**SECTION 00 91 05  
ADDENDUM NUMBER 5**

**DATE:               SEPTEMBER 7, 2017**

**PROJECT:           ORCHARD VALLEY CLUBHOUSE HVAC RENOVATIONS  
2411 W ILLINOIS AVENUE  
AURORA, ILLINOIS 60506**

**PROJECT NO:       17-253-1110**

#### **4.01 DRAWING ME200 - MECHANICAL AND ELECTRICAL DEMOLITION FLOOR PLANS**

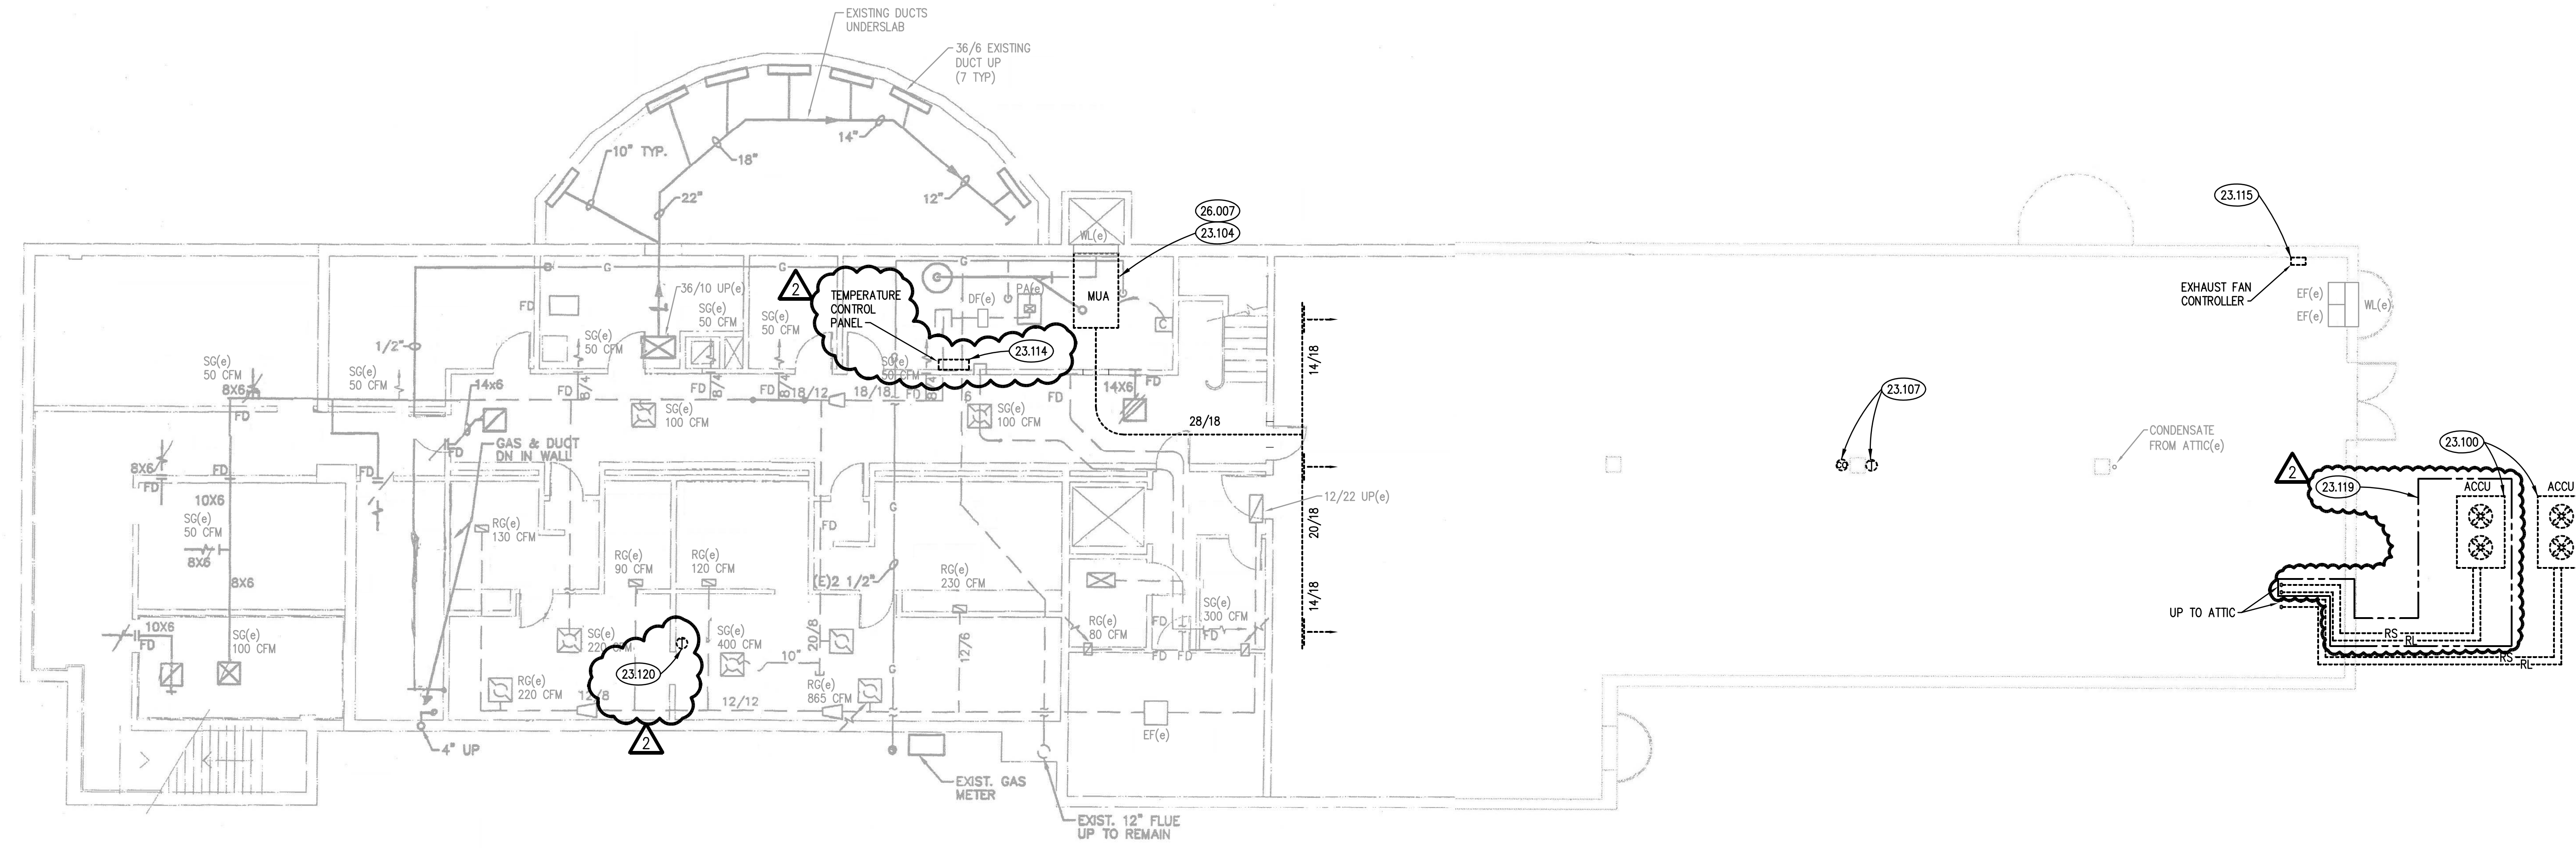
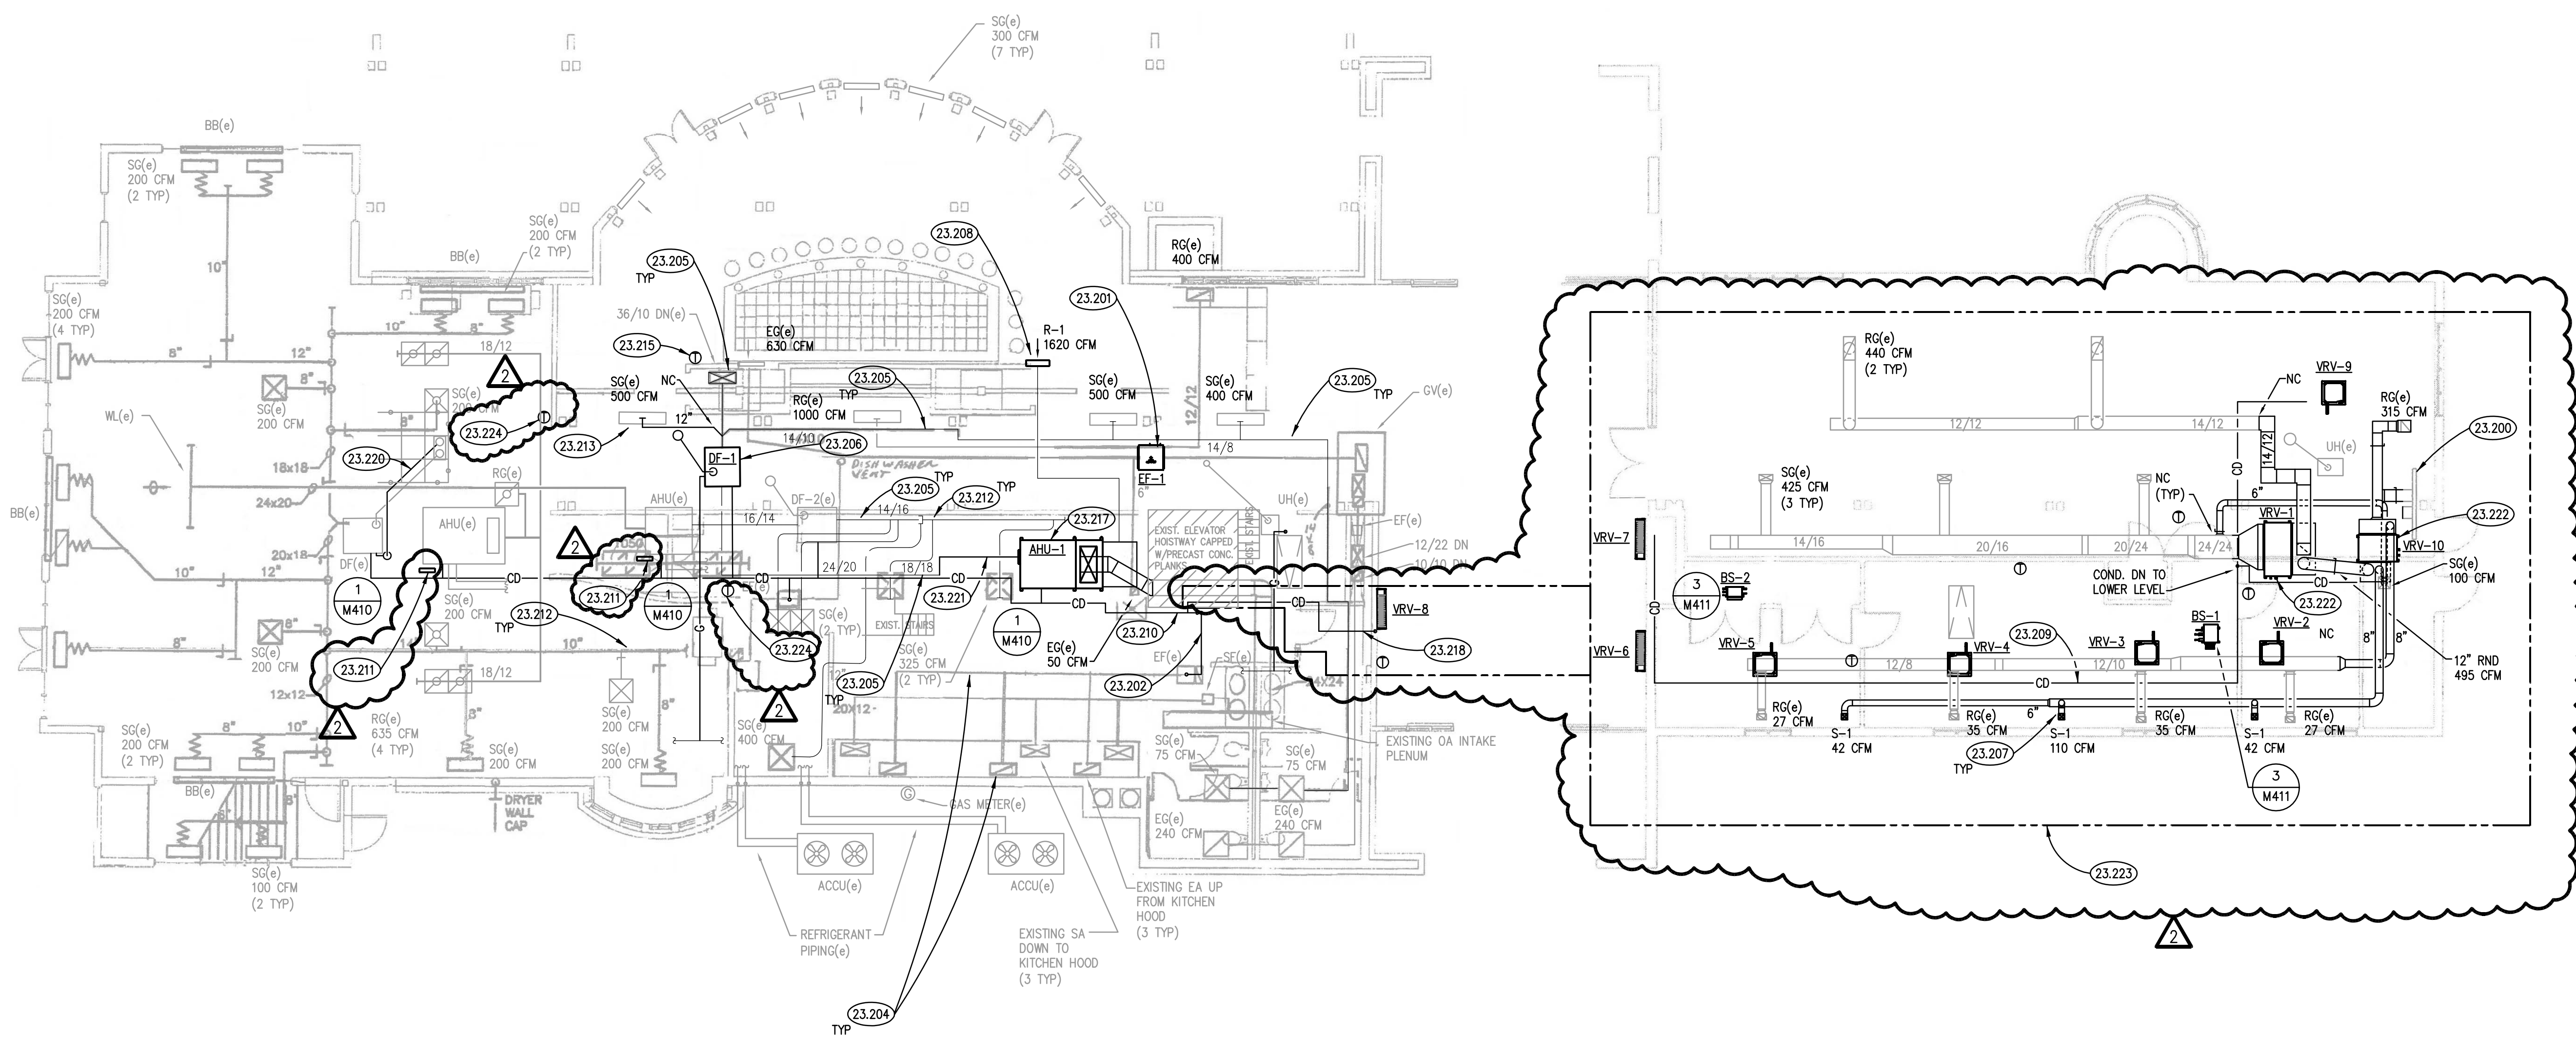
A. Delete this Drawing in its entirety and replace with revised Drawing ME200 - MECHANICAL AND ELECTRICAL DEMOLITION FLOOR PLANS (attached).

- 23.117 REMOVE COMBUSTION AIR INTAKE FOR DUCT FURNACE. NEW COMBUSTION AIR INTAKE TO BE ROUTED OVERHEAD.
- 23.118 REMOVE RETURN GRILLE IN BAR AREA.
- 23.119 ALTERNATE NO. 1 - ALL WORK IDENTIFIED IN OUTLINED AREA ASSOCIATED WITH THE REMOVAL OF AHU ABOVE PRO SHOP SHALL BE PART OF ALTERNATE NO. 1 WORK SCOPE. (REFRIGERANT PIPES PASSING THROUGH ATTIC TO AHU ABOVE KITCHEN IS BASE BID WORK SCOPE.)

- 23.120 ALTERNATE NO. 2 - REMOVE THERMOSTAT FOR AIR HANDLING UNIT.
- 26.006 DISCONNECT, PROTECT AND RECONNECT BRANCH CIRCUIT TO MECHANICAL EQUIPMENT INDICATED TO BE REPLACED.

#### **4.02 DRAWING M300 - MECHANICAL FLOOR PLANS**

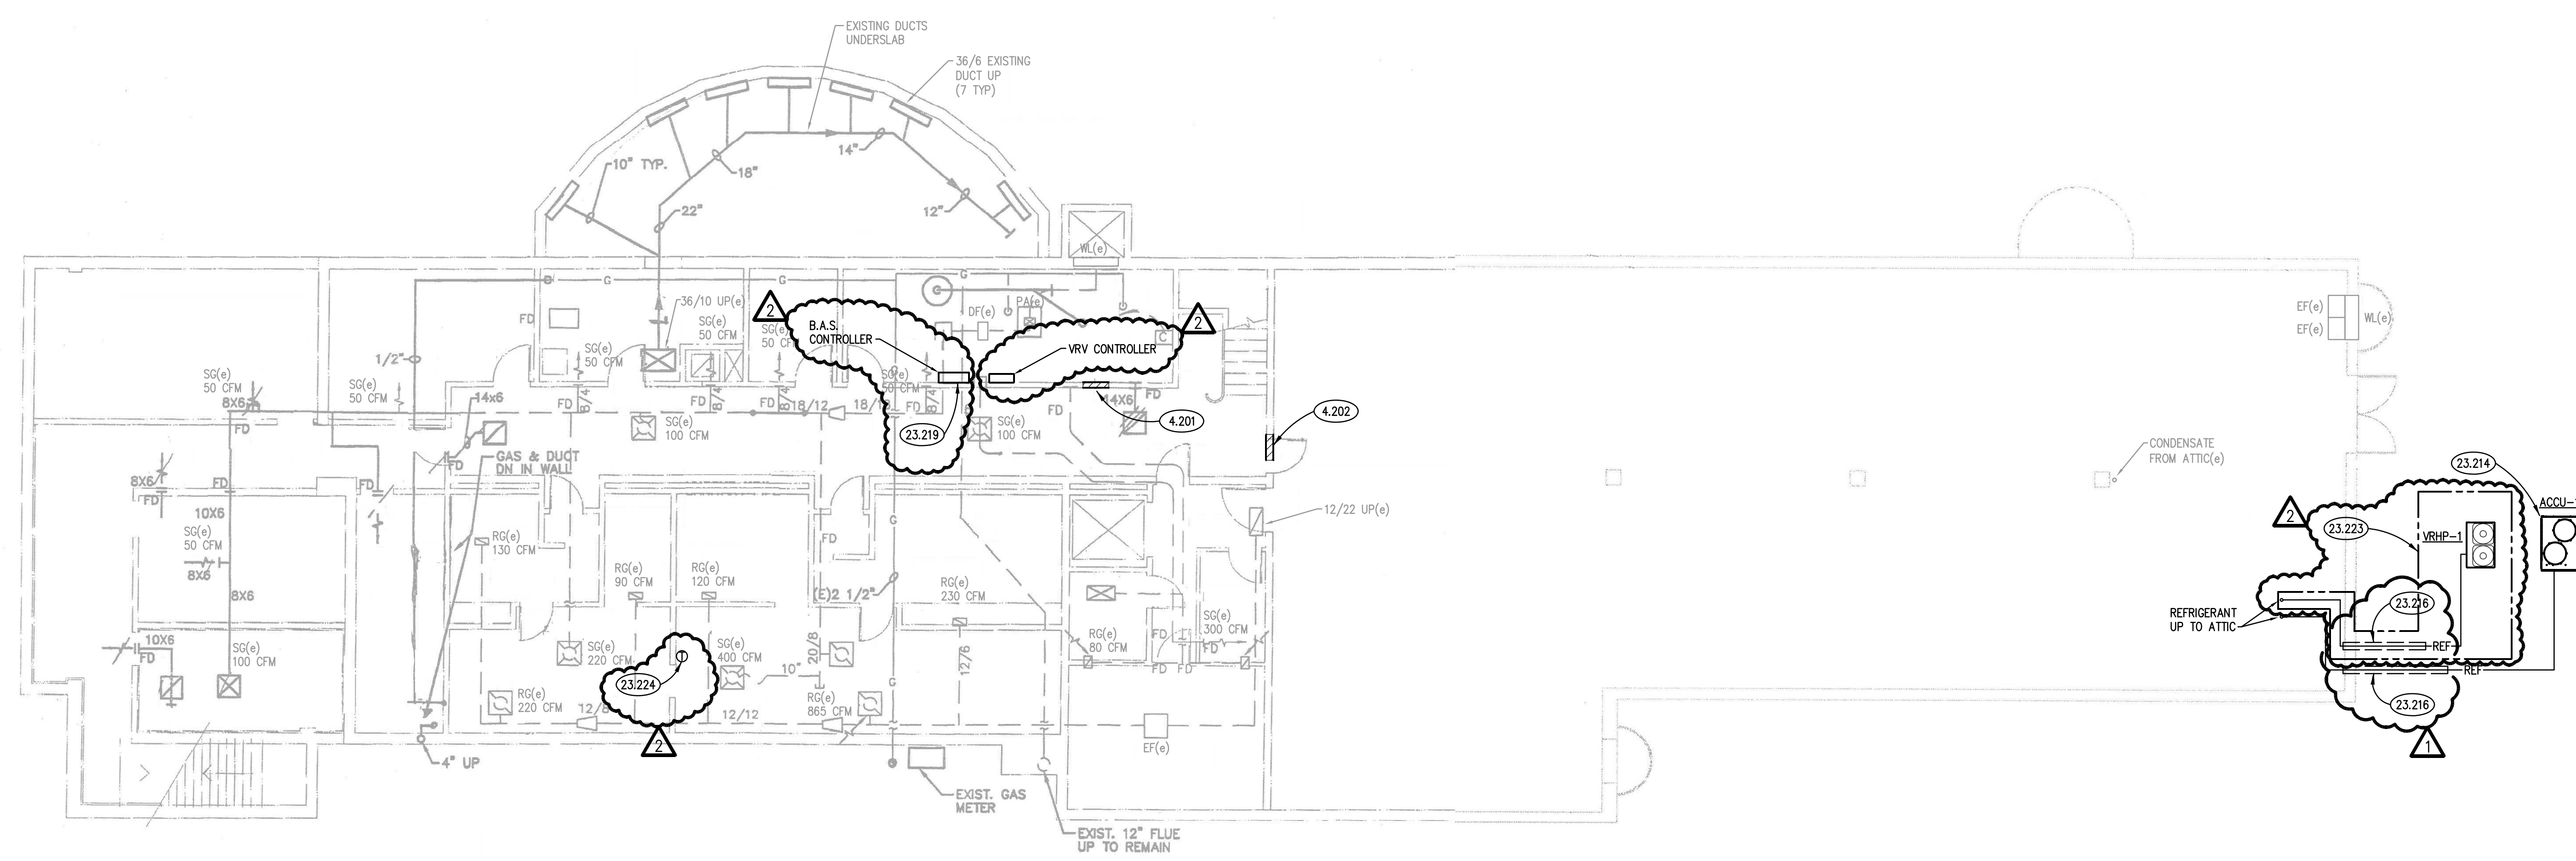
A. Delete this Drawing in its entirety and replace with revised Drawing M300 - MECHANICAL FLOOR PLANS (attached).

23.223 ALTERNATE NO. 1 - ALL WORK IDENTIFIED IN OUTLINED AREA ASSOCIATED WITH VARIABLE REFRIGERANT SYSTEM ABOVE PRO SHOP SHALL BE PART OF ALTERNATE NO. 1 WORK SCOPE.

23.224 ALTERNATE NO. 2 - PROVIDE NEW THERMOSTAT FOR AIR HANDLING UNIT.
